Hallandale Hotel 804 S Federal Hwy

Major Development Review | Redevelopment Area Modifications (RAMs)

Application No. DB-24-04402 | RD-24-04428

City Commission March 19, 2025

Site Plan

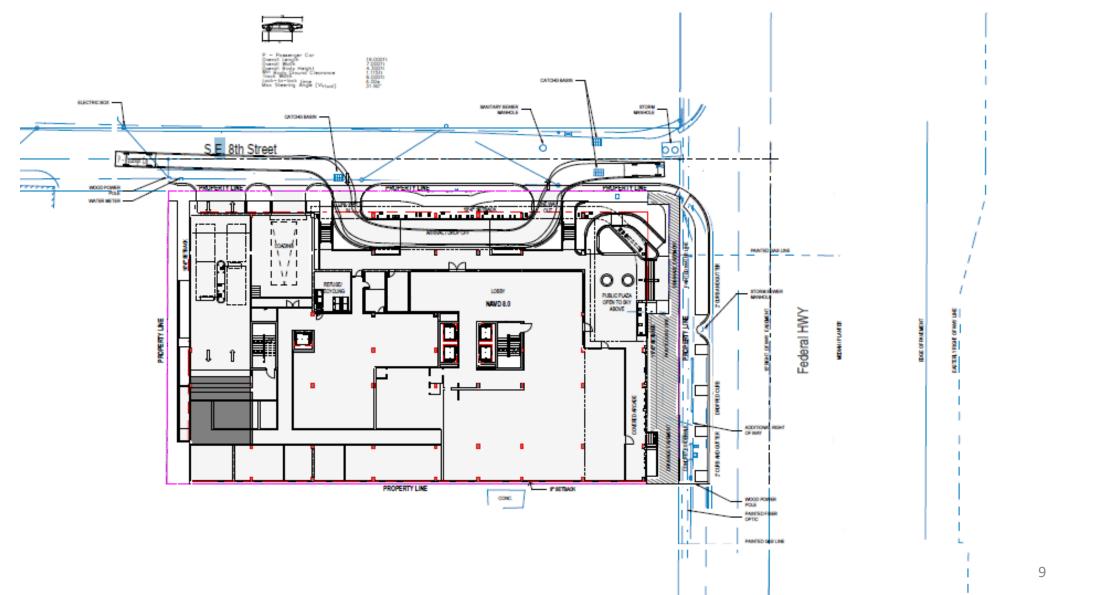
- 5. The 5-foot sidewalk along SE 8th Street shall be located on-site. The applicant must execute a sidewalk easement, in a form acceptable to the City Attorney, for the on-site construction of the sidewalk before the building permit for the project is issued.

- 8. The Applicant shall contract with the City for roll-out service by the Sanitation Division for servicing the dumpster/trash disposal.
- 9. The hotel drop-off area, parking, loading and refuse pick-up shall function as illustrated on site plan and Operations Plans. Any modifications to the Operational Plans shall be considered by the Department of Sustainable Development Director or designee. The City of Hallandale Beach maintains the right, in perpetuity, to have the property owner modify the Operations Plan as necessary to address any unforeseen operational or safety issues after the hotel has opened.

Parking – Level 4 Floor Plan

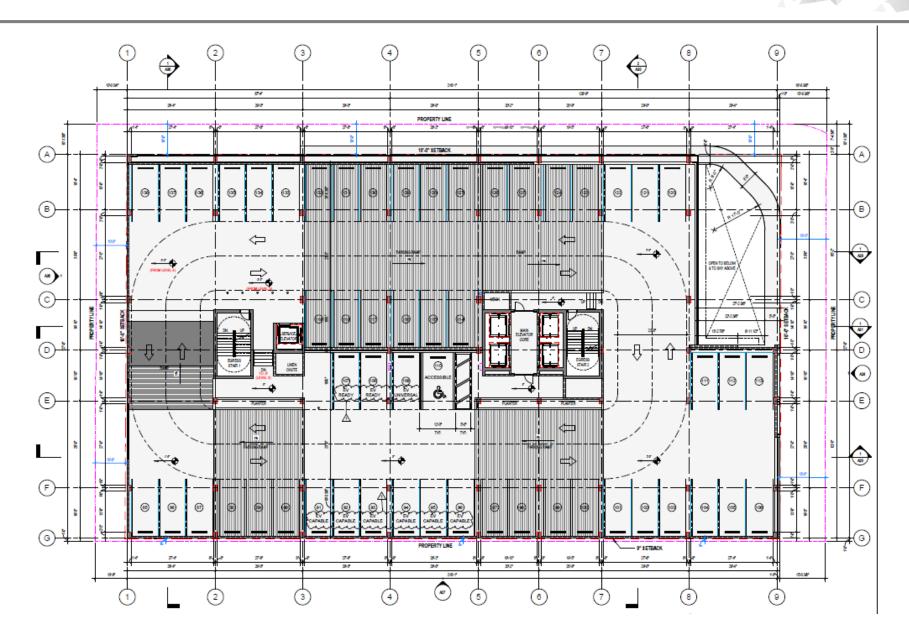
- 11. Elimination of parking spaces #190 -193 at the dead-end drive in Level 4 of the parking garage to allow for additional maneuvering area.
